**PARK CITY MUNICIPAL CORPORATION
PLANNING COMMISSION
CITY COUNCIL CHAMBERS
October 25, 2017**

PARK CITY MUNICIPAL CORPORATION
PLANNING COMMISSION MEETING MINUTES
COUNCIL CHAMBERS
MARSAC MUNICIPAL BUILDING
OCTOBER 11, 2017

1. Treasure Hill Conditional Use Permit, Creole Gulch and Town Lift Mid-station Sites – Sweeney Properties Master Plan (Application PL-08-00370)

V17.2 - 2017 Refinements #2 to 2009 Submittal
Building & Site Section

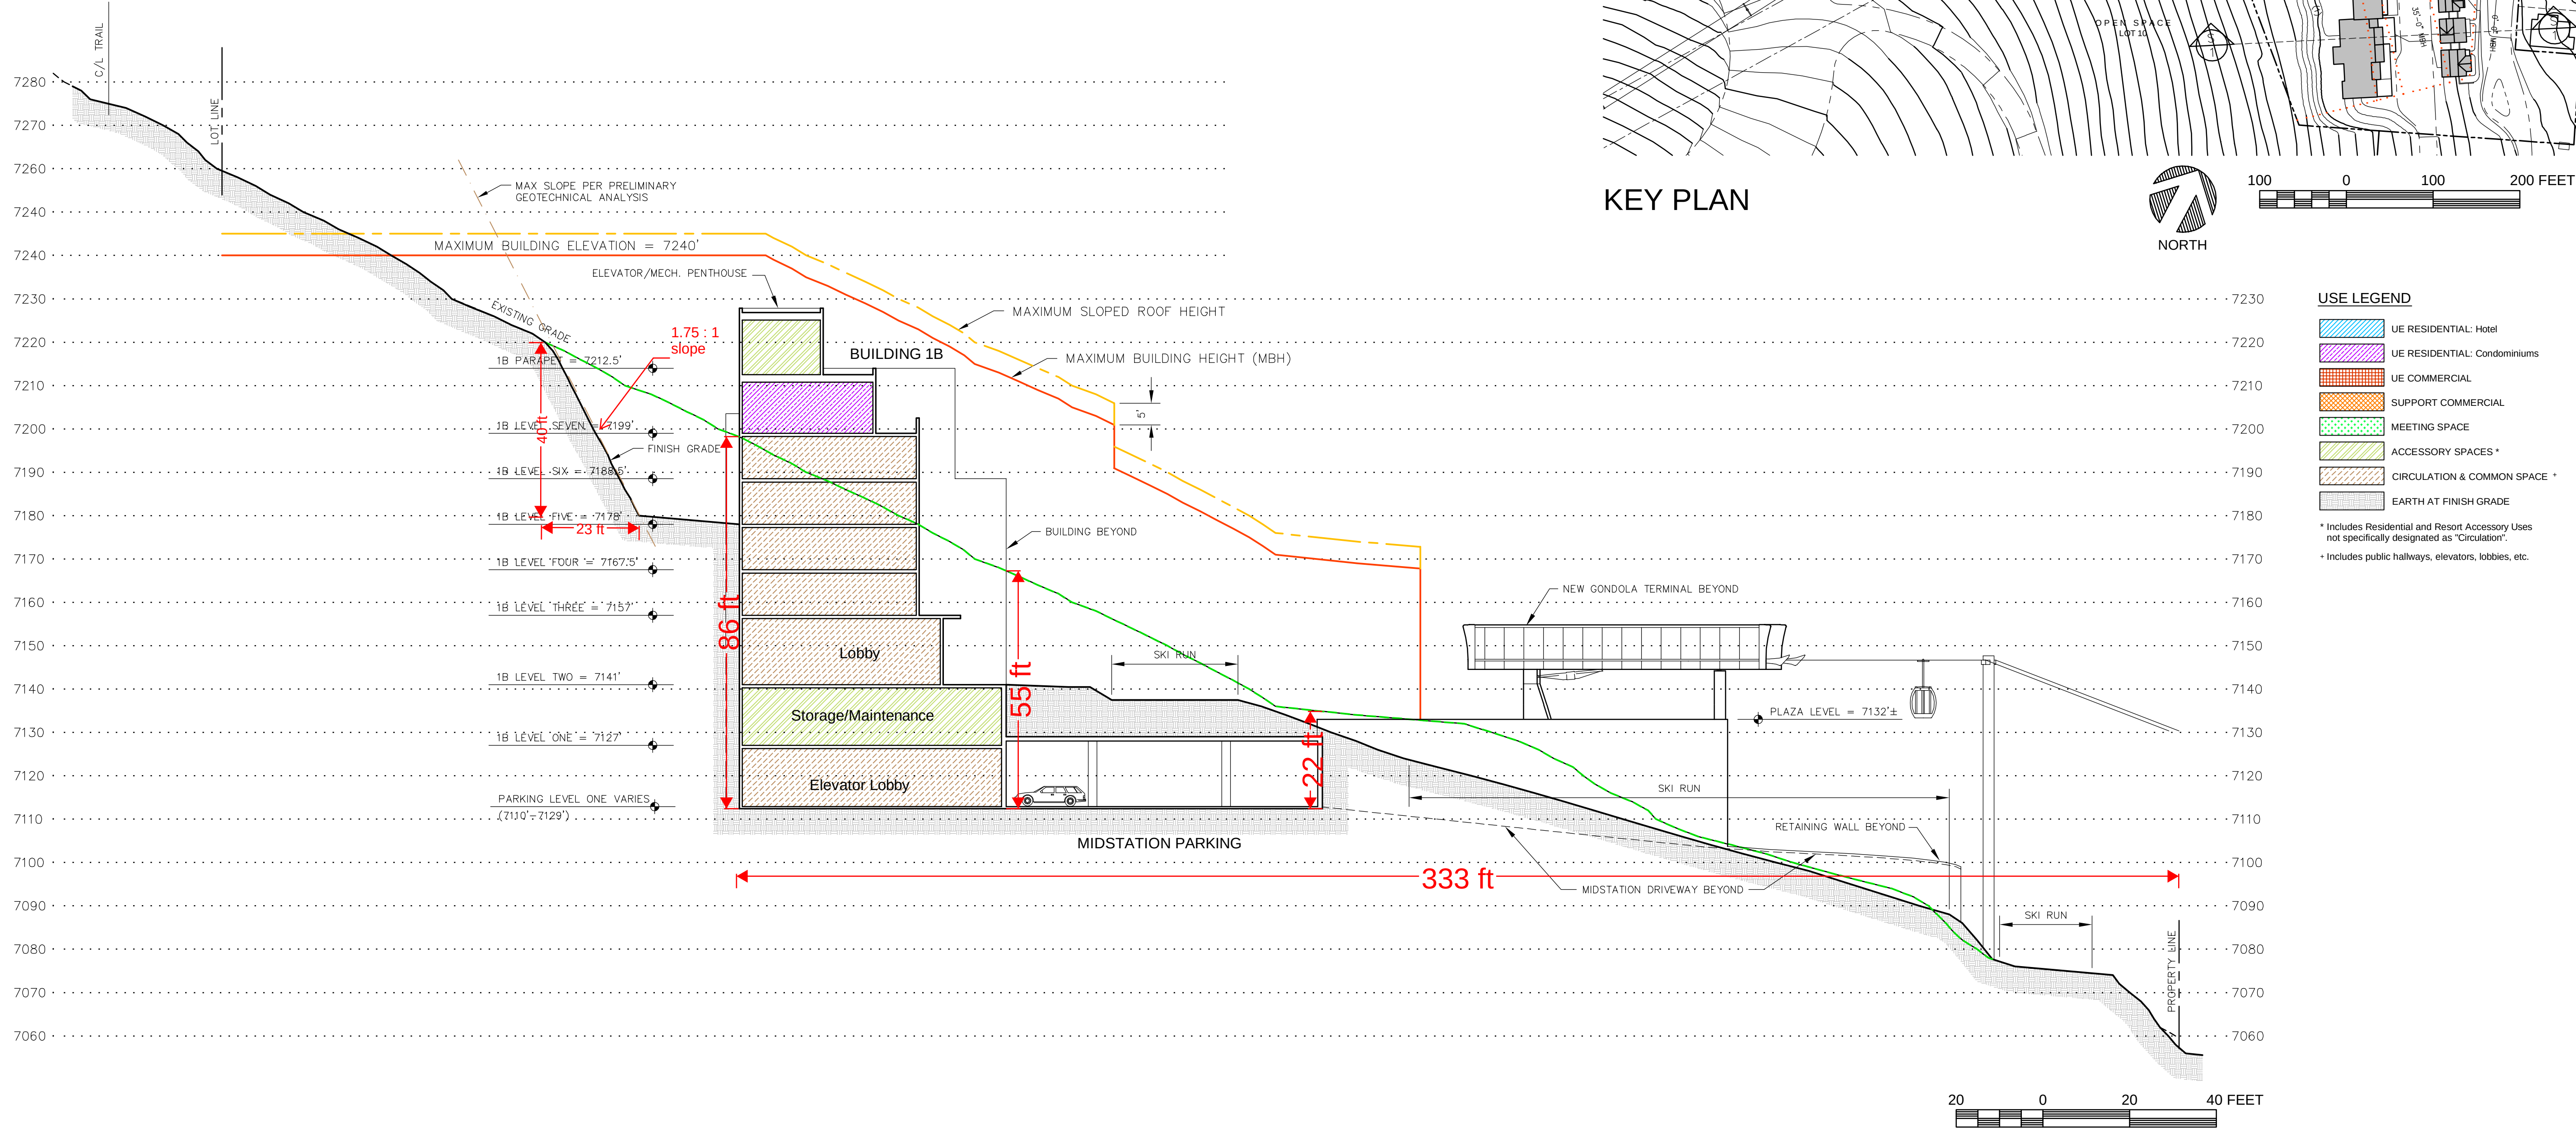
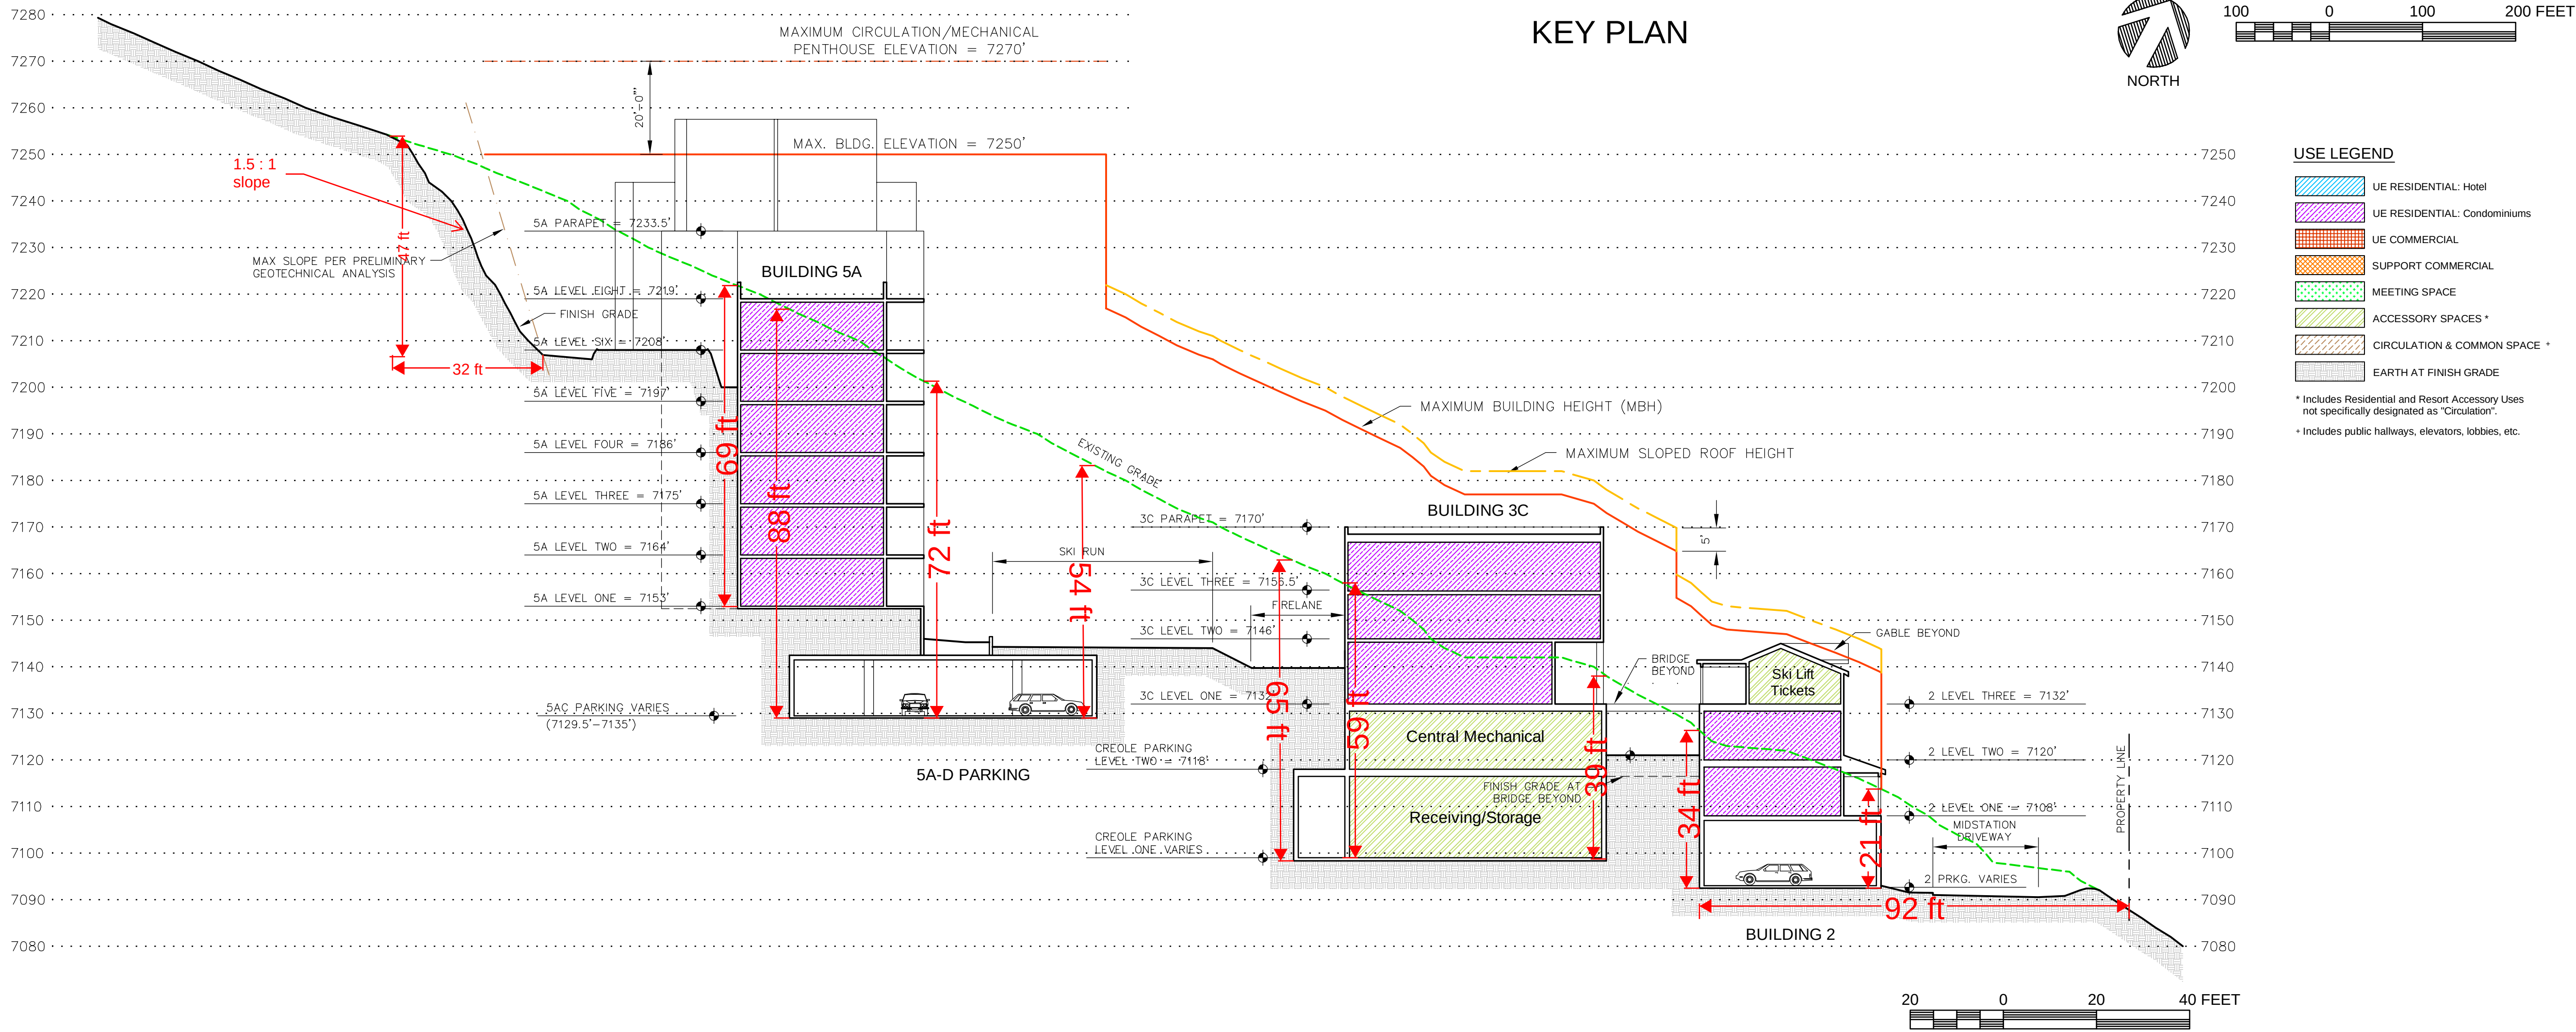
4. Refinement 17.2 building sections, sheet S.1 – S.9, are not the same building sections shown on the master plan due to the change in number of buildings, building locations, etc.
